**BULGA OPTIMISATION
PROJECT MODIFICATION 3
AND BULGA UNDERGROUND
MODIFICATION 7**

Submissions Report

December 2019

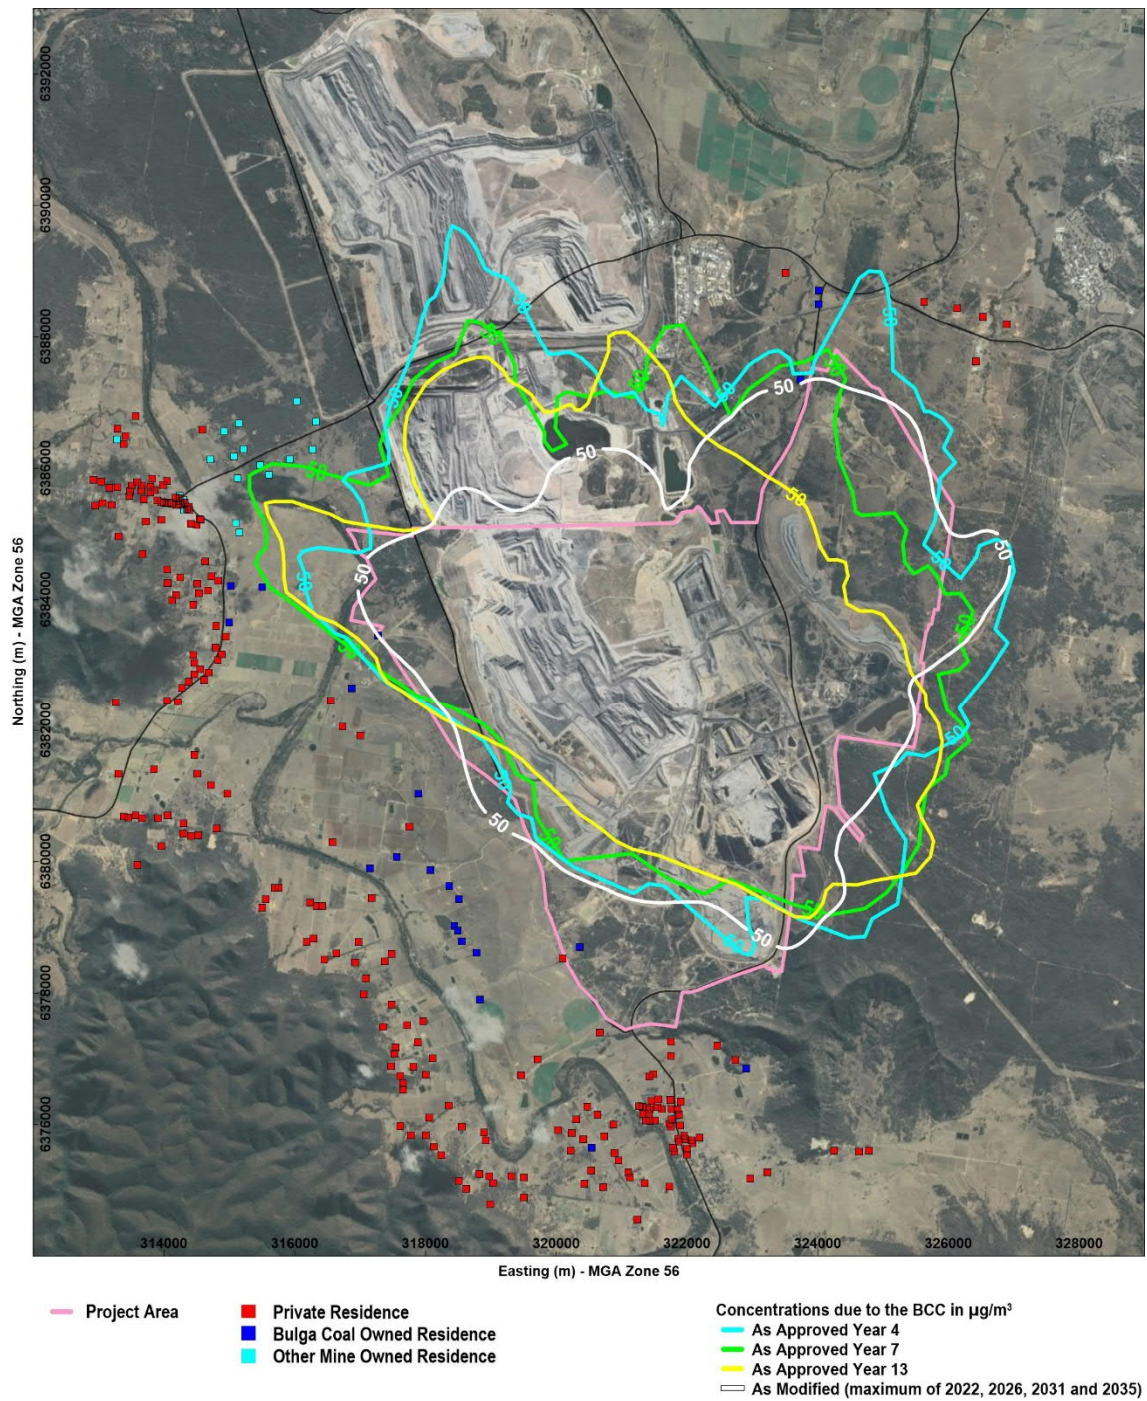
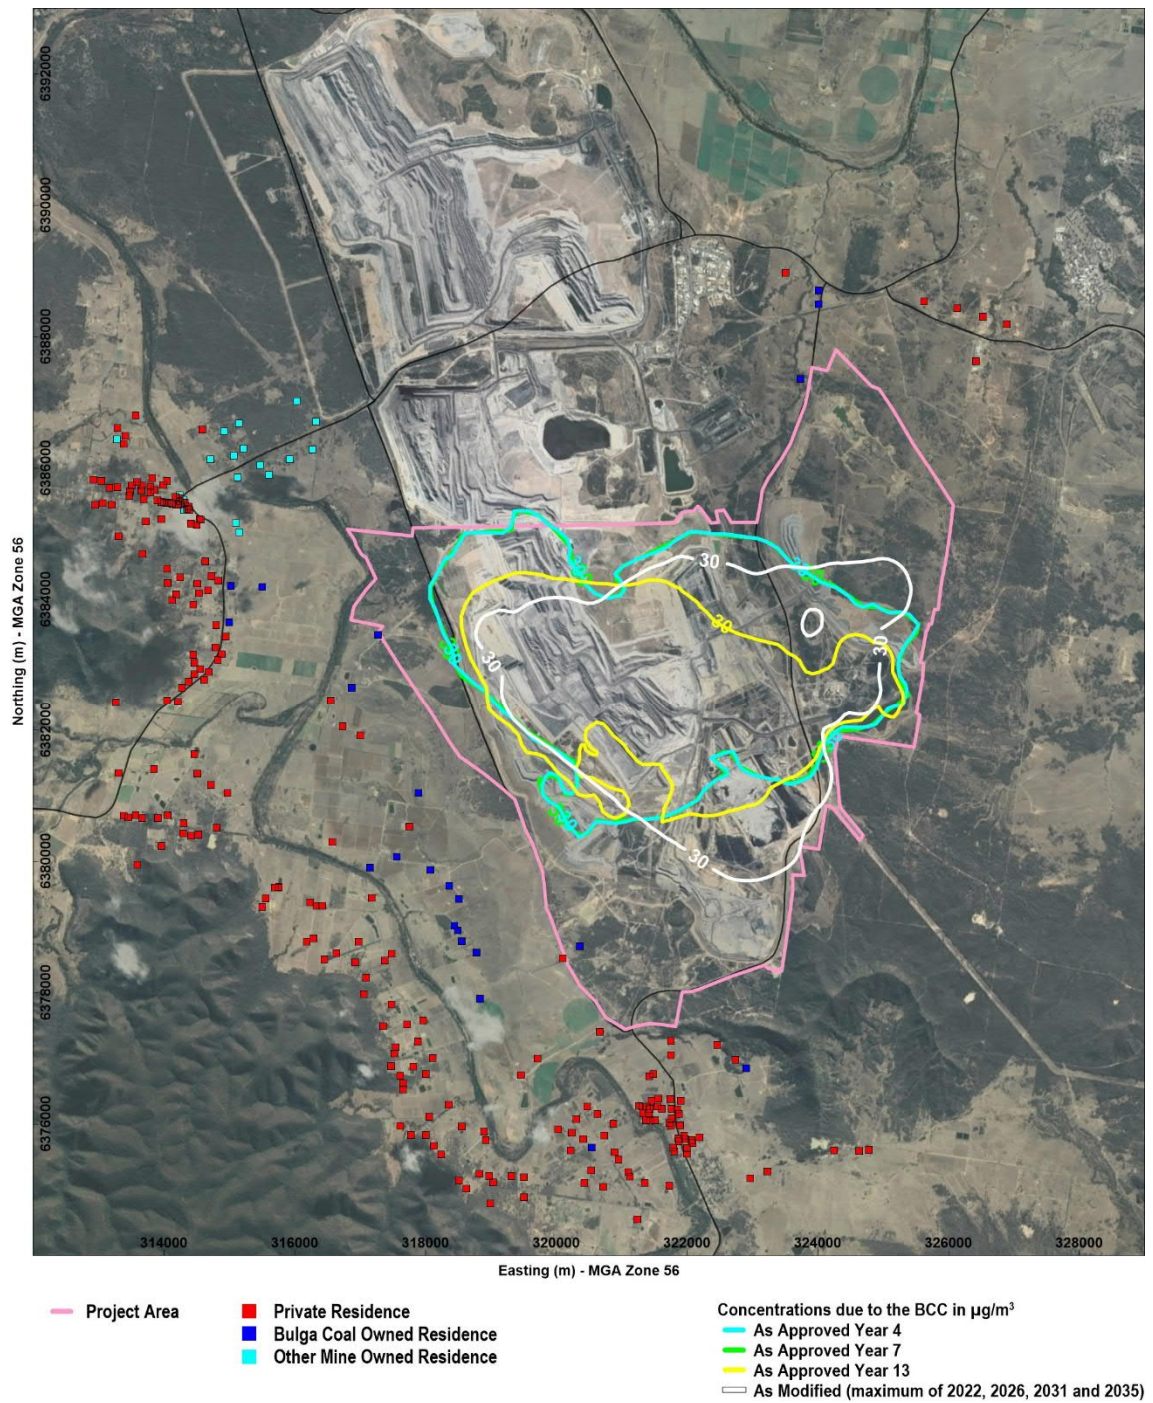
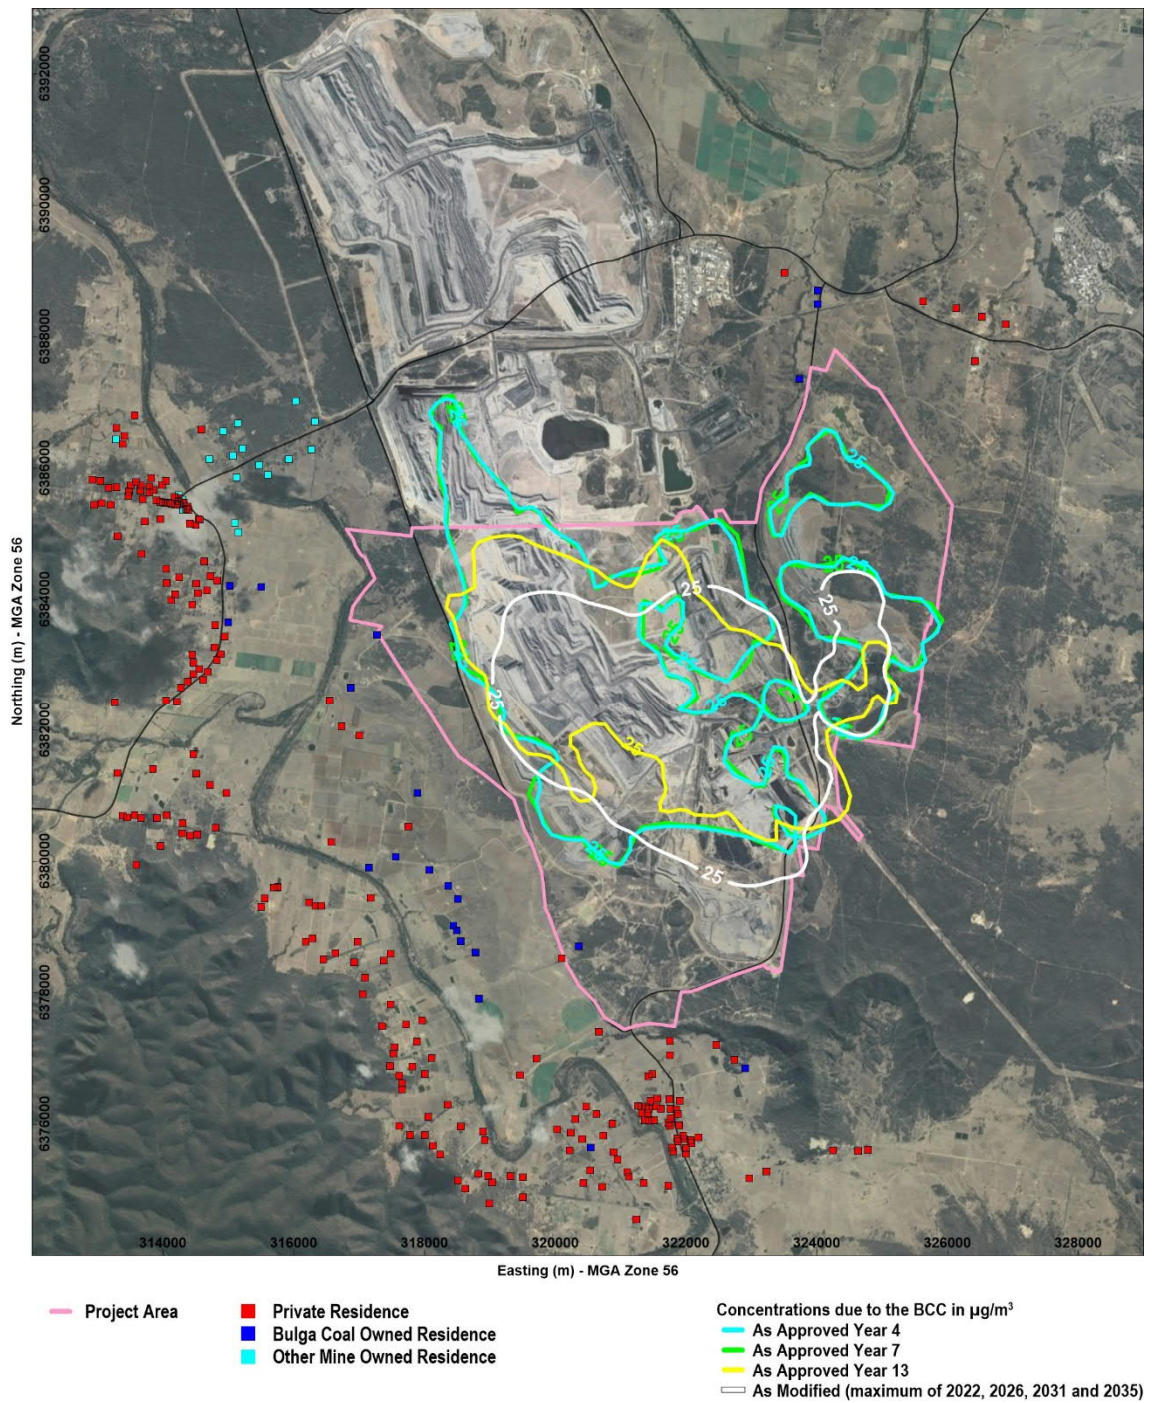
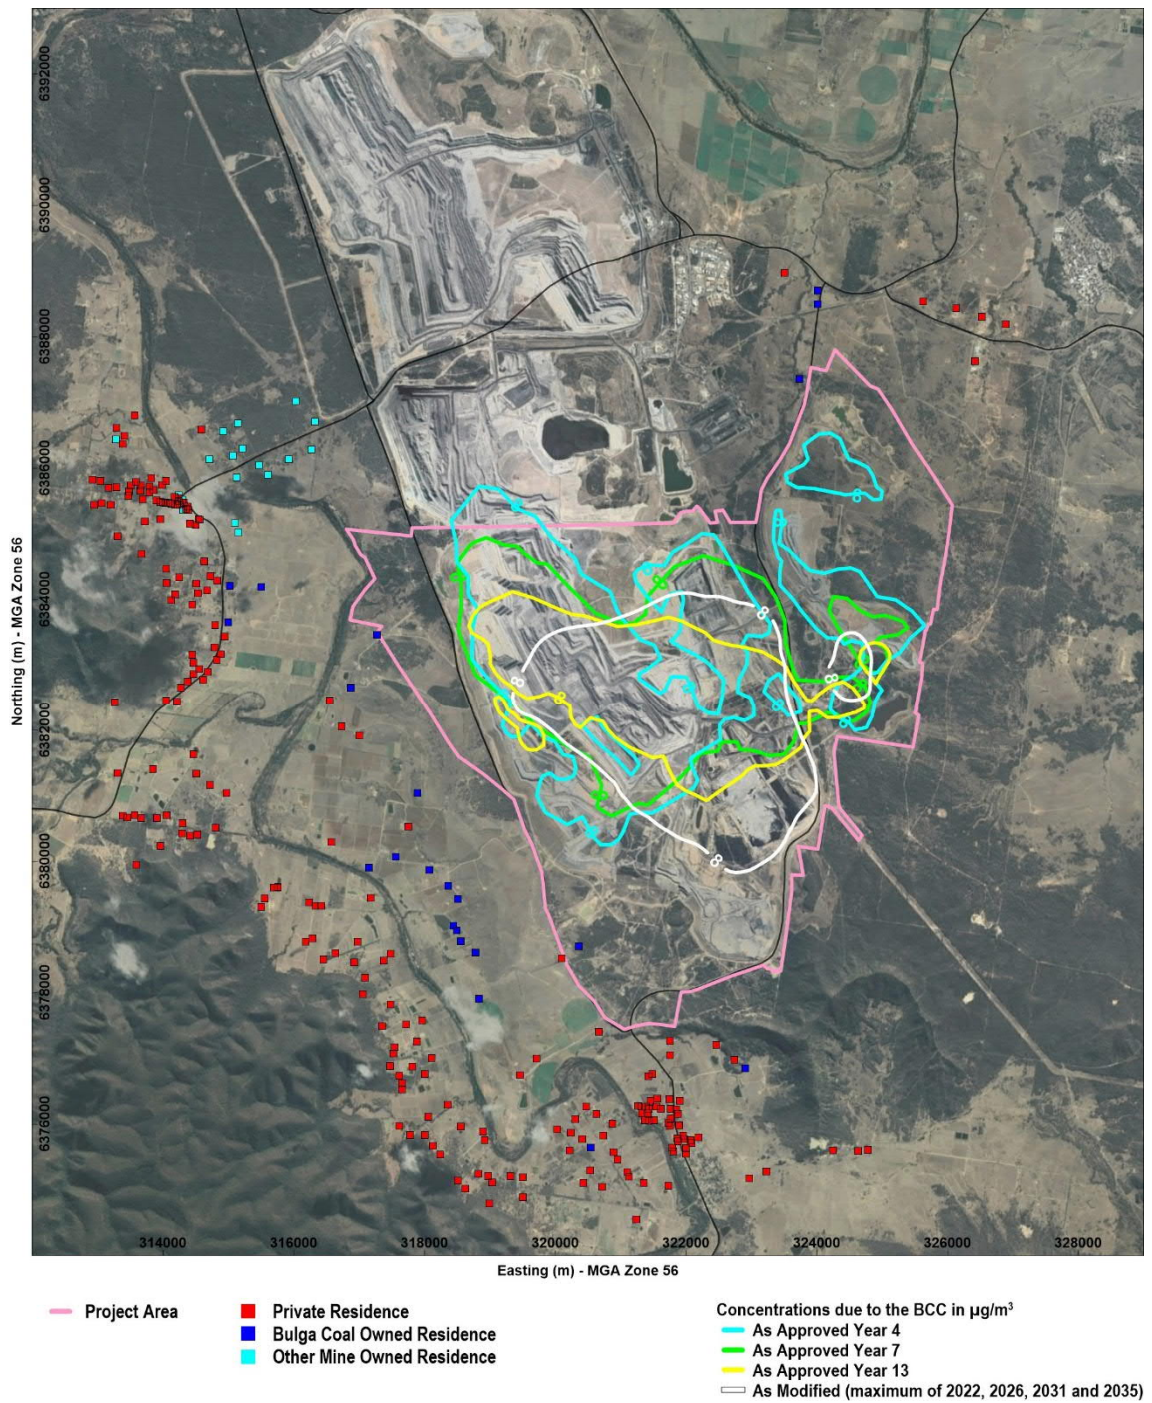
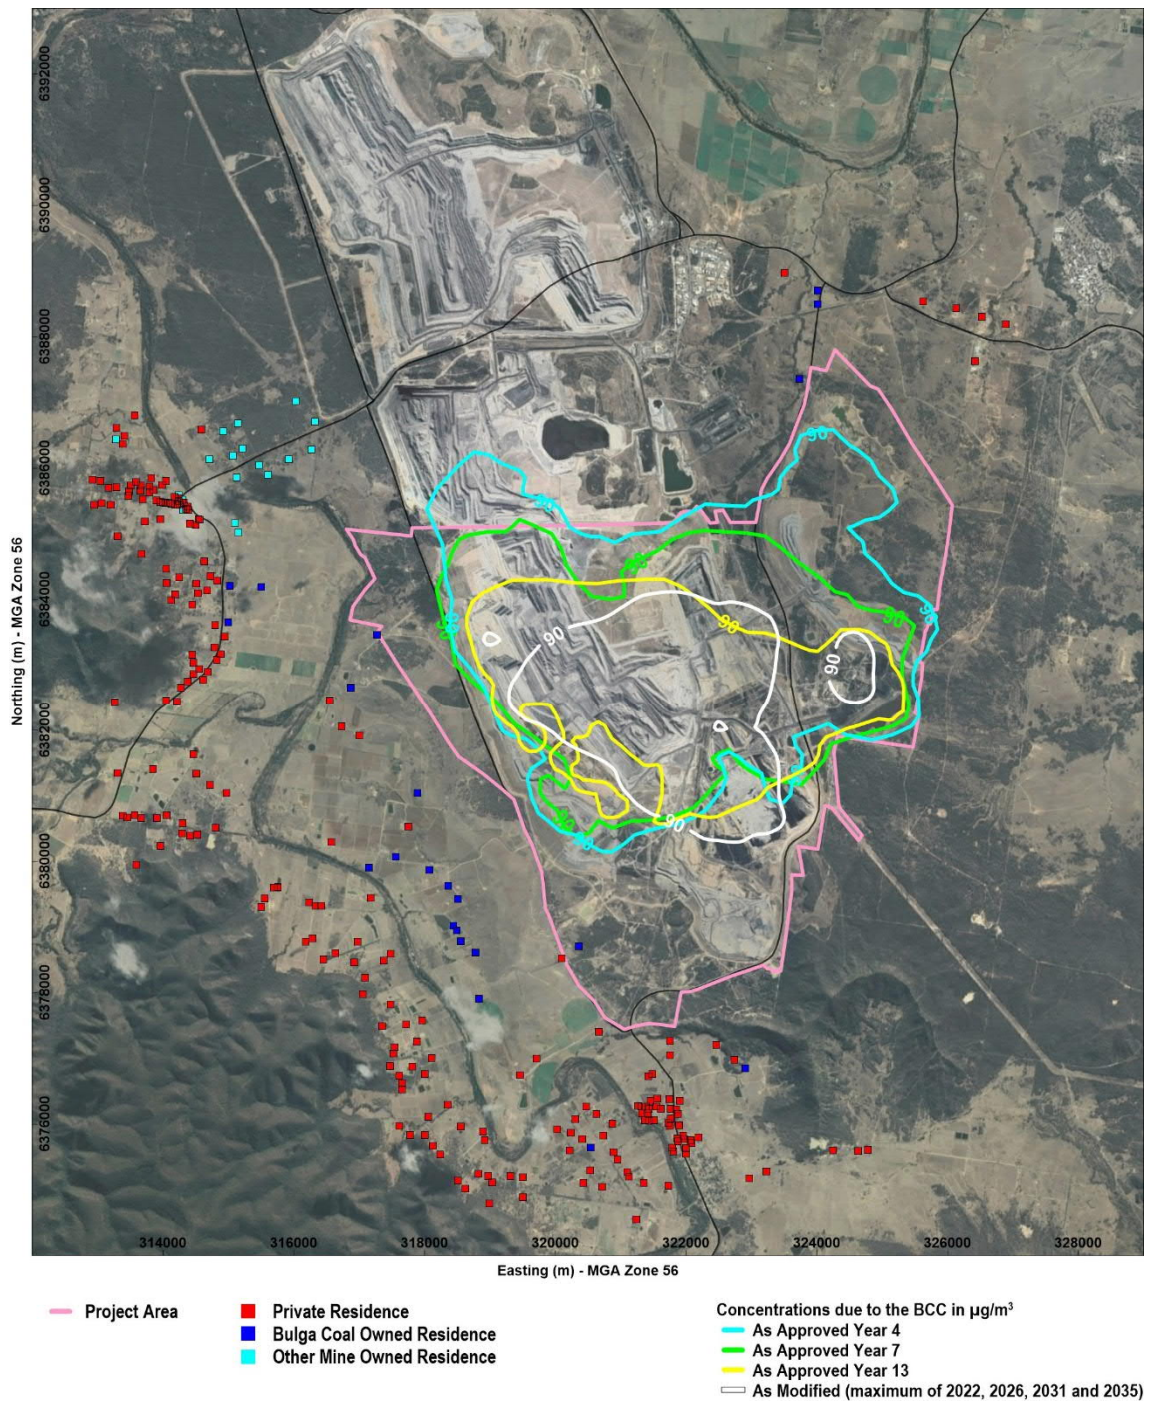
The Proponent must provide an assessment of particulate emissions from the existing approved operations at the Bulga Coal Mine and evaluate changes to air quality resulting from SSD 4960 Mod 3. This assessment is needed because the modification will result in new activities to the south of the existing project area. Incremental dispersion contour plots must be included.

The Air Quality Impact Assessment (AQIA) does not present a complete assessment of the air quality impacts from the current approved operations. Rather assumes SSD 4960 Mod 3 will not change air quality impacts. Predicted impacts above the assessment criteria are to occur to the north-east and north-west of the Bulga Coal Mine, towards Bulga. However, no particulate impacts above the EPA's assessment criteria are predicted to the south of the Bulga Coal Mine towards Broke. It is unclear how these impacts compare to the existing approved operations of Bulga Coal Mine.

Contour plots have been prepared to provide a comparison of the Proposed Modification to the Approved Development, in terms of the contribution of the BCC to local air quality. These plots are shown in **Figure 1** to **Figure 6** and include:

The comparisons in **Figure 1** to **Figure 6** show that the key contours representing the contribution of the Proposed Modification (i.e. BCC with SSD-4960 Mod 3) to local air quality are largely within those of the Approved Development in terms of maximum extent. Some deviations are evident, for example, annual averages show a change in contribution to the south due to proposed area mining in this area, and some of these differences are also explained by the factors outlined above.
